REMARKS

Amendments to the Drawings:

Amendment in Reply to Office action of September 8, 2004 Annotated Sheet Showing Change(s)

FIG. 2B

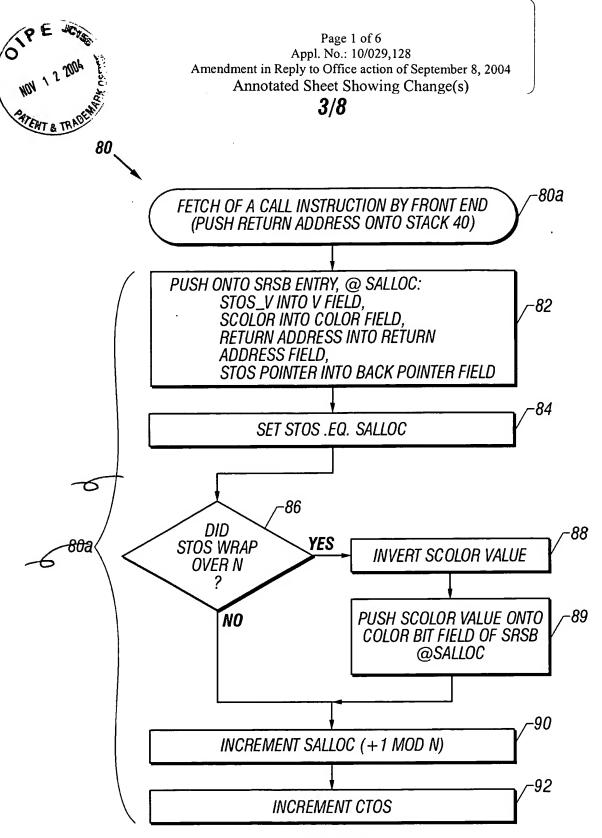
In Figure 2B, the reference 80a identifying the sequence of actions, 82-92, has been removed.

FIG. 2C

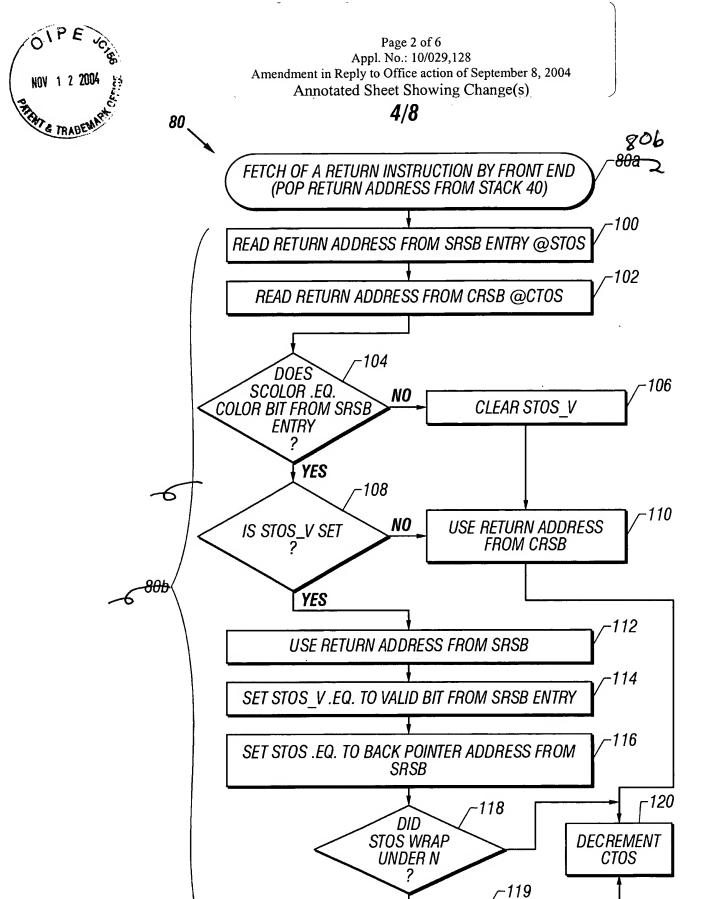
In Figure 2C, the reference 80a has been changed to 80b, and the reference 80b identifying the sequence of actions, 100-120, has been removed.

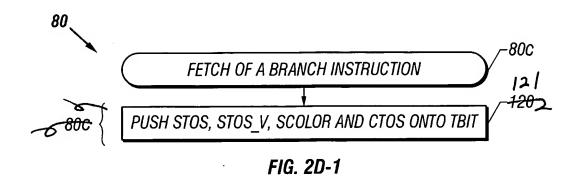
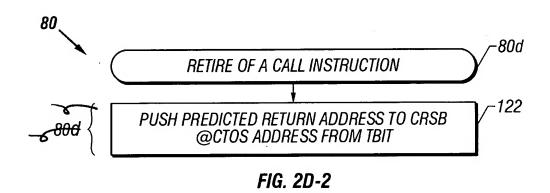
In Figure 2D-1, the reference 120 has been changed to 121, and the reference 80c identifying the action, 120 (now 121), has been removed.

In Figure 2D-2, the reference 80d identifying the action, 122, has been removed.

In Figure 2D-1, the reference 80f has been changed to 80e, and the reference 80e identifying the sequence of actions, 126-128, has been removed.

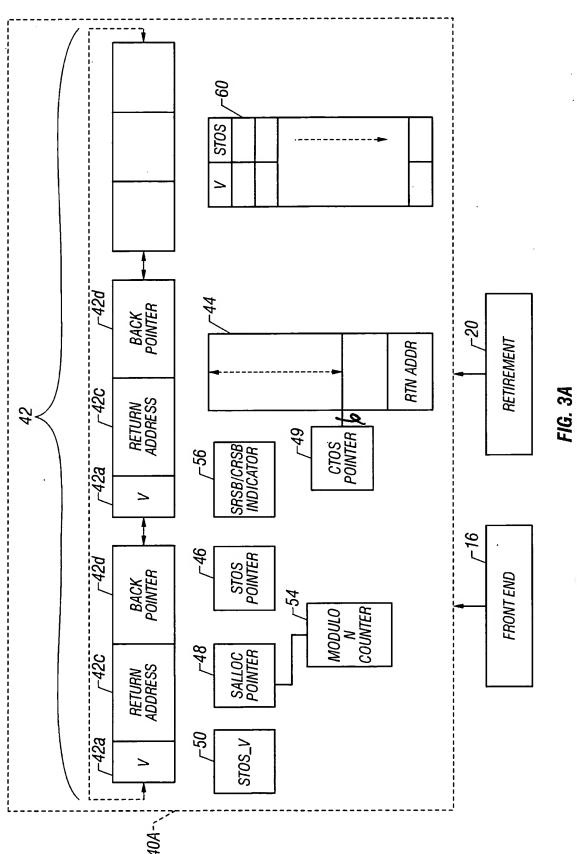
In Figure 3A, an extra line connecting the CTOS pointer 49 and the CRSB 44 has been removed.

In Figure 3B-1, the reference 140a identifying the sequence of actions, 141-146, has been removed.

FIG. 3B-2

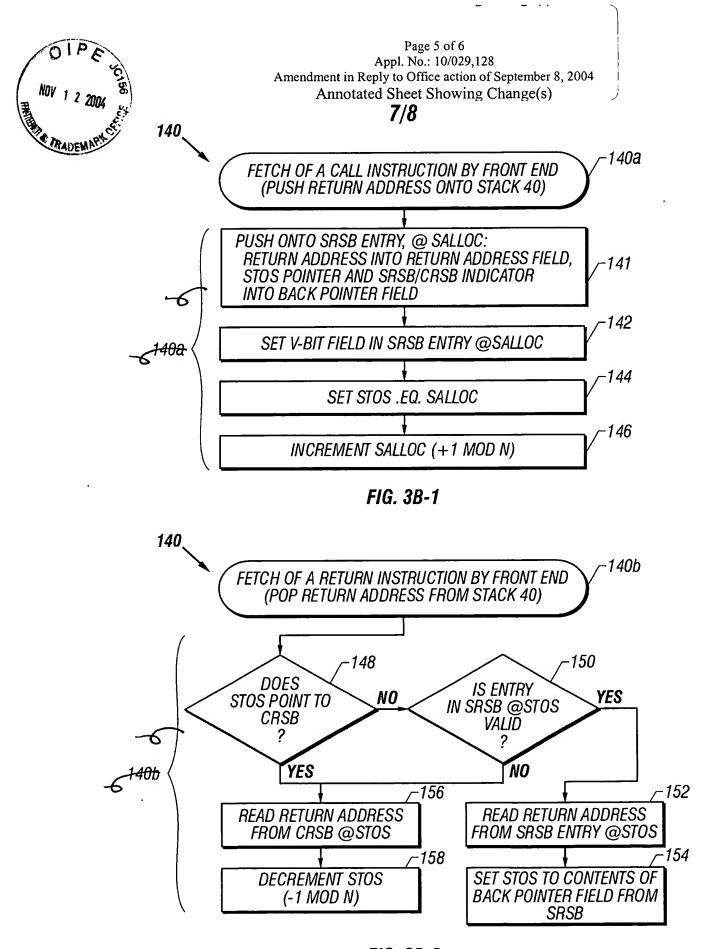
In Figure 3B-2, the reference 140b identifying the sequence of actions, 148-158, has been removed.

FIG. 3C-4

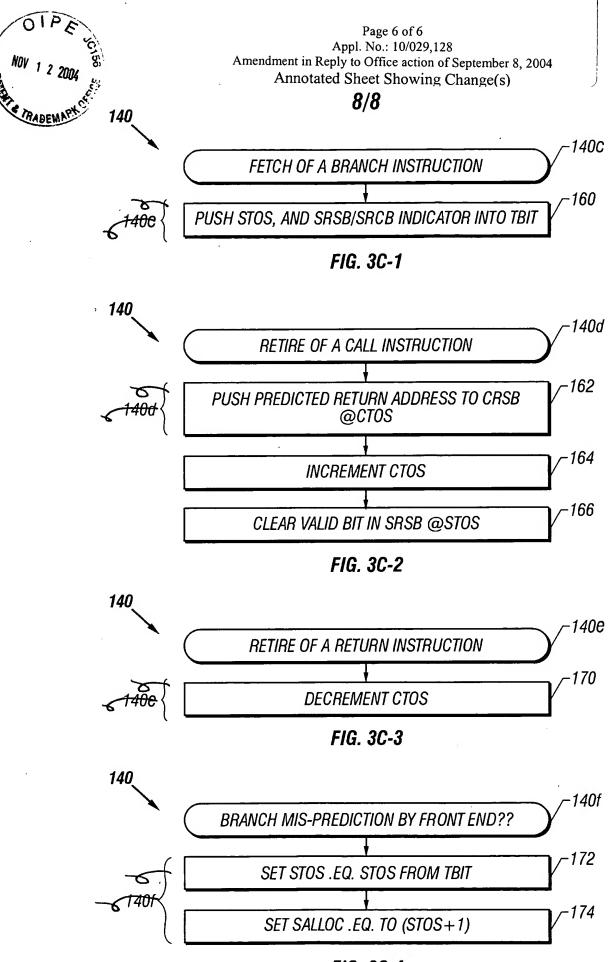
In Figure 3C-1, the reference 140c identifying the action, 160, has been removed.

In Figure 3C-2, the reference 140d identifying the action, 162, has been removed.

In Figure 3C-3, the reference 140e identifying the action, 170, has been removed.

In Figure 3C-4, the reference 140f identifying the sequence of actions, 172-174, has been removed.
